Unit F

First Addendum to conditions, specifications, related documents and drawings entitled:

UNIT F - PHARMACY AND NURSING FACILITY (P/N)

UNIVERSITY OF MINNESOTA - MINNEAPOLIS CAMPUS
HEALTH SCIENCES EXPANSION
PROJECT NOS. MINN. BHRD-HP-5C-063
BHRD-NU-5C-077

APPENDIX NO. 2
LIGHTING
ROOM 2-108

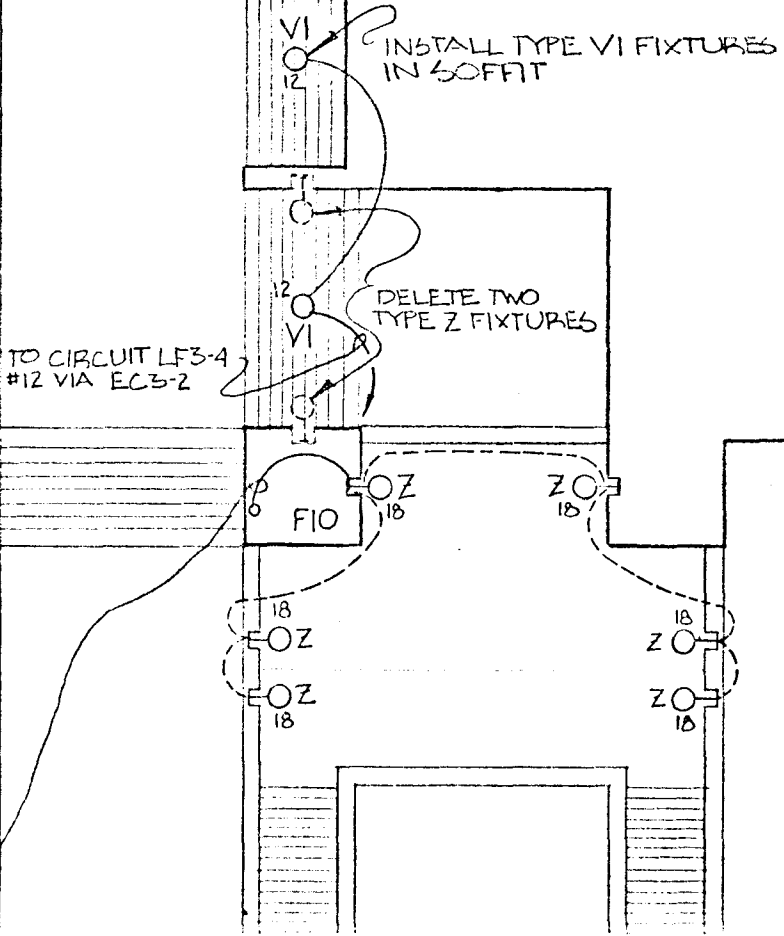
- (C) Type "Q" light fixture in Room 2-111 should be shown as recessed.
- (D) Refer to Appendix C, sheet 1, for changes to lighting in Room 2-108.
- 88 - Drawing E5: (A) Detail 2. Refer to Appendix C, sheets 2 and 3, for changes to exterior lighting.

CHANGE SPECIFICATION 16410 2.2, A 1., b. TO READ: LIGHTING CONTACTOR SHALL BE ELECTRICALLY HELD, 20 A, 3 POLE N.O. WITH 120 V COIL INSTALLED IN A NEMA 1 ENCLOSURE. SQUARE D, CLASS 8903 LG-80.

DETAIL 11/E37 - CHANGE TO SHOW 8 POLE CONTACTOR (2 SPARE) WITH TWO ADDITIONAL CIRCUITS FOR FIXTURES ADDED IN THIS ADDENDA

CHANGE CONTACTOR SCHEDULE SHEET E-37 TO SHOW ADDED CONTACTS AND CIRCUITS FOR CONTACTOR EC3-2

ADD TWO 20A 1P C.B.'S TO PNL LF3-4 ON PANEL BOARD SCHEDULE SHEET E38. NO. OF SPARES TO REMAIN THE SAME
